Technical change to 1890521500

the product 1890521500 (SAIL-M12BG-8S15U) will be changed after a transitional period.
Please pass on this Product Change Notification (PCN) to your employees and, if applicable, to your customers.

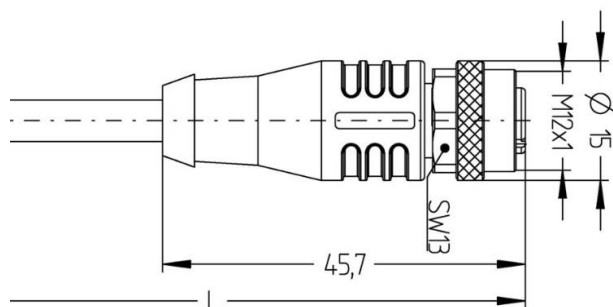
- Standardization of the product family. All length variants of the 189052* are now in the same design.
